ITEM FOR ENVIRONMENTAL COMMISSION AGENDA

**Name & Number
of Project:** 8818 Big View #4
SP-2014-0227DS

MEMORANDUM

SUBJECT: 8818 Big View Drive #4 – SP-2014-0227DS

boat dock plans
and elevations

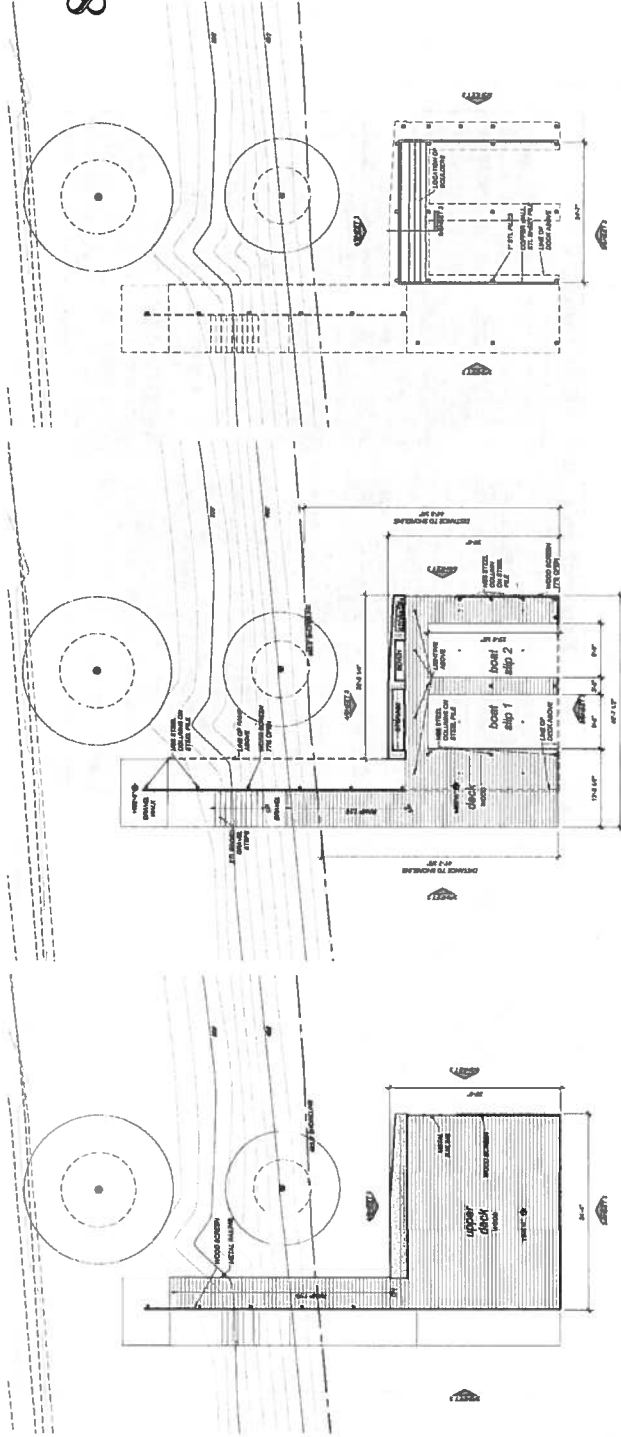
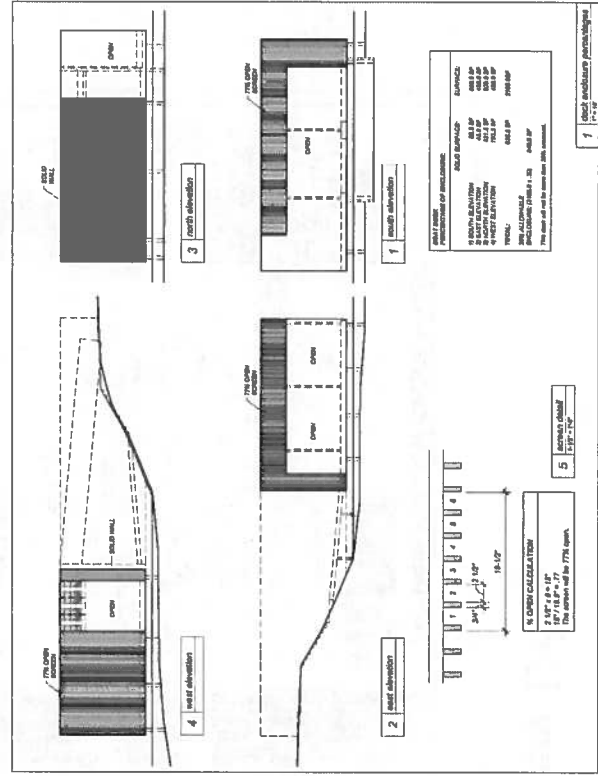
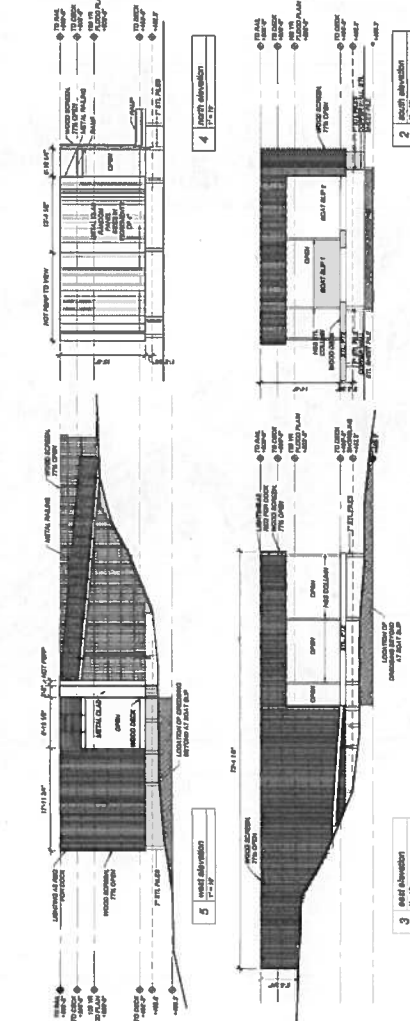
Reasons for The project can be built with much less dredge and therefore the request
for 56 yards is considered excessive.

Environmental staff finds the amount of dredging excessive and will have a detrimental impact on the natural character of Lake Austin. Additionally, a dock can be constructed without the dredging in excess of 25 cubic yards.
